**MODIFICATION WORK ORDER**

**MODIFICATION OF  
M93 PALADIN MUZZLE VELOCITY SYSTEM  
(NSN 1290-01-412-5759)  
(EIC: 3TC)**

HEADQUARTERS, DEPARTMENT OF THE ARMY, WASHINGTON D.C.

15 December 2005

FIGURE 1

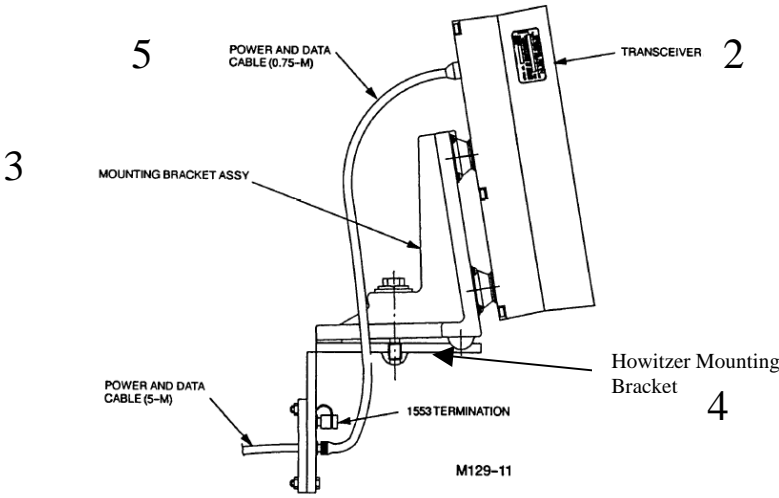
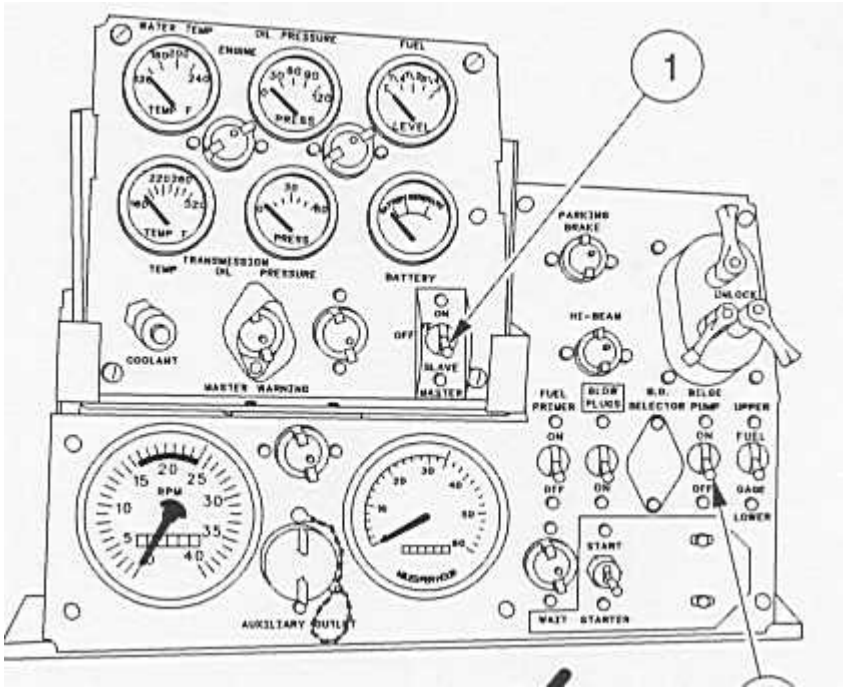
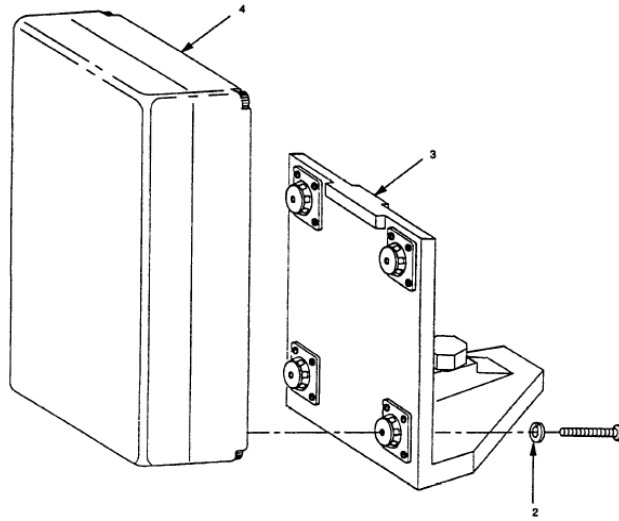
c. **PROCEDURES FOR REMOVAL:** The M93 Paladin Muzzle Velocity System must be removed from the howitzer in accordance with the following steps and figure 1:

- (1) Ensure that the vehicle **MASTER** switch (1) is in the **OFF** position.
- (2) Disconnect W92 power and data cable (5) from M93 radar antenna transceiver (2).
- (3) Remove antenna-mounting bracket (3) from howitzer mounting bracket (4) by unscrewing the hex head mounting bolt (fig. 3, item 1) securing the two brackets together.

**f. INSTALLATION:** Install the transceiver and mounting bracket to the howitzer in accordance with the following steps and figure 1.

(2) Position antenna-mounting bracket (3) on howitzer bracket (4).

(4) Install mounting bracket with attached transceiver to the howitzer's bracket and torque main bolt to between 450 and 500 in-lb (37.5-41.67 ft-lb).

(5) Connect W92 power and data cable (Fig. 1, Item 5) to M93 (upgraded) transceiver (Fig. 1, item 2).

**Figure 2**

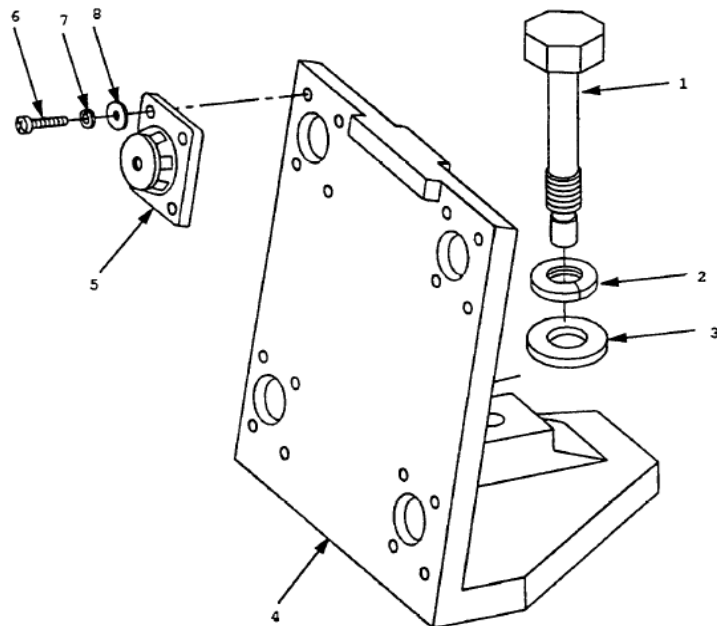
(a) Unscrew and remove four screws (1) and four lock washers (2) that secure transceiver (4) to bracket assembly (3). See paragraph 8d regarding disposition of hardware.

(b) Remove and set aside for disposition per paragraph 8d, the transceiver (4) from bracket assembly (3).

(2) Transceiver to antenna-mounting bracket. Install the following parts in accordance with the following steps and figure 2:

(a) Correctly position transceiver (4) on bracket (3).

(b) Install four new screws (1) and four new lock washers (2).

(c) Using a hex head torque wrench (table 5), tighten each mounting bolt to between 60 and 70 in-lb (5.00-5.83 ft-lb).
